# **Board of Adjustment**

## **Agenda**

**June 15, 2016**  
**City Hall, Council Chambers**  
**749 Main Street**  
**6:30 PM**

**CITY OF LOUISVILLE**  
**BOARD OF ADJUSTMENT**  
**STAFF REPORT**  
**June 15, 2016**

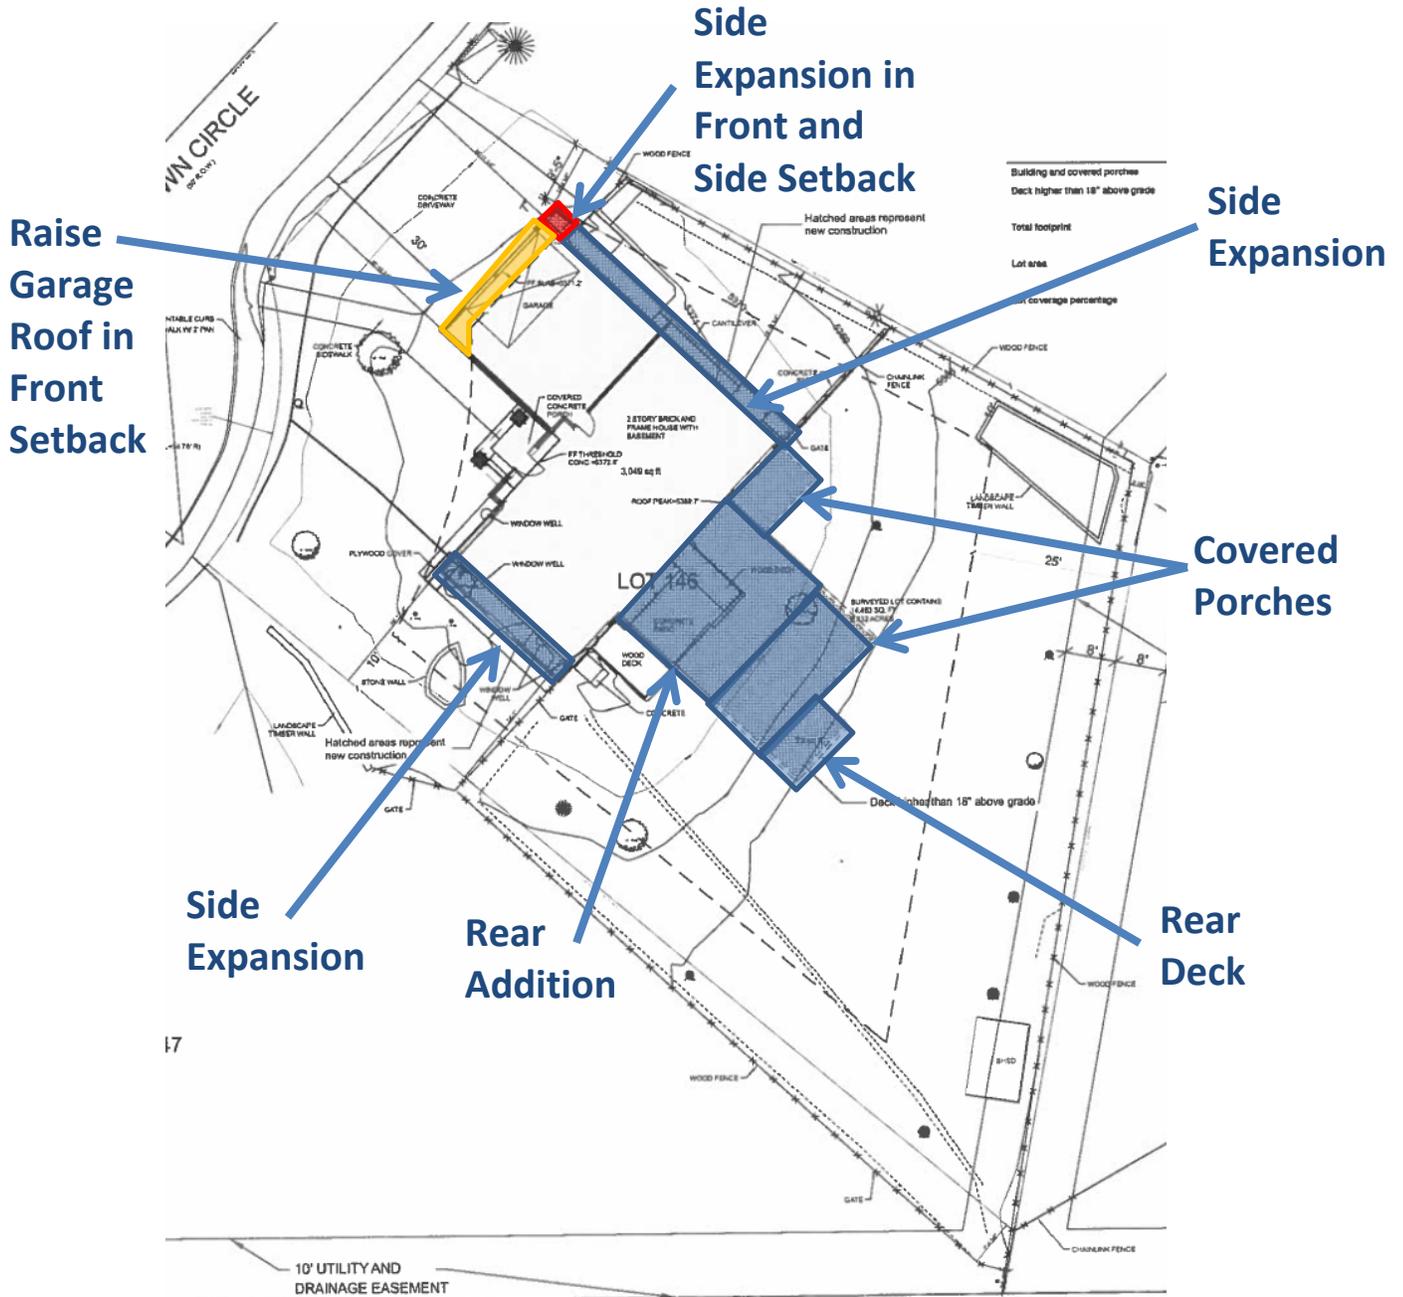
**Setbacks:** The lot in question is irregularly shaped, being wider at the rear than at the front and with the cul-de-sac further impacting the front lot line. In addition, the front of the house currently encroaches into the front setback. **Staff finds this criterion has been met.**

**Lot Coverage:** The lot is 14,453 square feet, 2,453 square feet larger than the 12,000 square foot minimum lot size in the RE zone district. The lot is appropriately sized for the zoning, and the 20 percent maximum lot coverage is appropriate for lots of this size. The split-level design of the house somewhat limits the ability to build up within the 35 foot height limit, however staff does not find anything unusual about the lot with respect to lot coverage. **Staff finds this criterion has not been met.**

Setbacks: The applicant is requesting to expand the garage to make it more useable. Staff considers it reasonable to expand the garage in line with the existing front of the structure. Because for the wedge shape of the lot and the angle of the house, extending the garage results in the corner encroaching into the side setback as well. The increased height of the garage does not add any square footage. Staff finds all of these changes reasonable. **Staff finds this criterion has been met.**

Lot Coverage: The applicant is requesting additions to the sides and rear, as well as covered porches and a deck. While all of these additions may be reasonable, together they cover too much of the lot. Staff believes the property could be enjoyed while staying under the allowed lot coverage limit. **Staff finds this criterion has not been met.**

Staff finds all applicable variance criteria in Section 17.48.110 of the LMC have been met with respect to the front and side setback variance requests and therefore recommends approval of those requests. Staff finds criteria 1, 2, and 3 in Section 17.48.110 of the LMC have not been met with respect to the lot coverage variance request and therefore recommends denial of that request.

**2<sup>nd</sup> Story Addition**

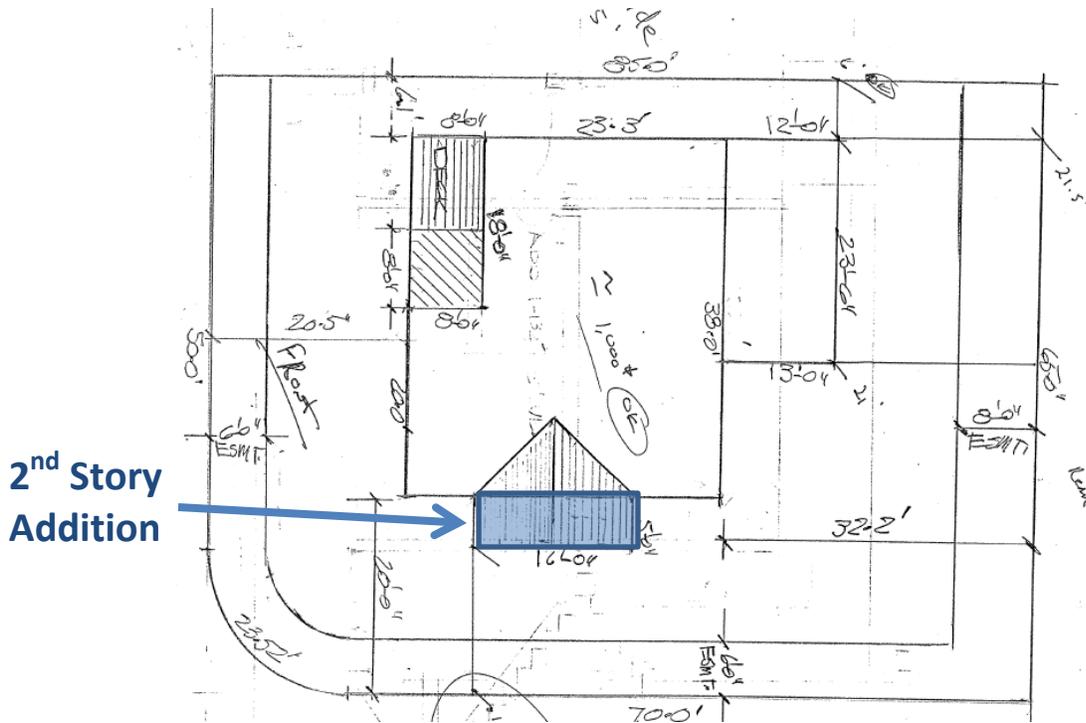
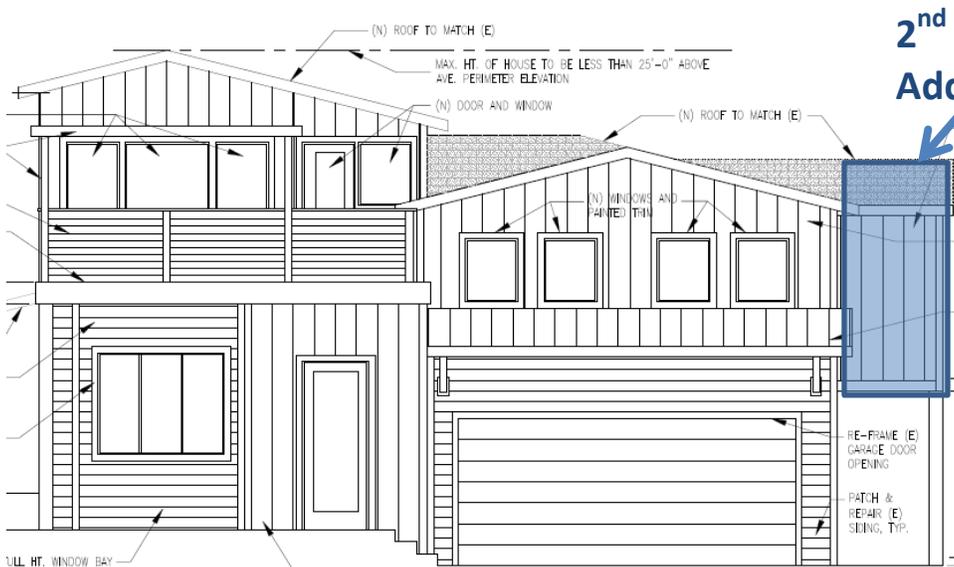
The lot in question is rectangular in shape and similar in size to the other properties in Dutch Creek. It is smaller than the minimum allowed lot size for a corner lot in the Residential Low Density (RL) zone district, at 5,724 square feet compared to the required 8,000 square feet. It is also narrower than allowed in the RL zone district, at 65 feet compared to the required 70 feet. The standard interior lots in Dutch Creek are 55 feet wide, which allows 45 feet of developable width with two five foot side setbacks. The 65 foot width of the lot in question has 40 feet of developable width, with a 20 foot and a five foot setback. So while the lot is not extremely narrow, it is narrower than standard for a corner lot and has less developable area. **Staff finds this criterion has been met.**

Most lots in Dutch Creek are narrower than the lot in questions, but, as described above, have more area available for development. However, most other corner lots in the subdivision are of similar width and are faced with the same setback requirements as the lot in question. Therefore, for similarly situated lots in the subdivision, the same circumstances are present. **Staff finds this criterion has not been met.**
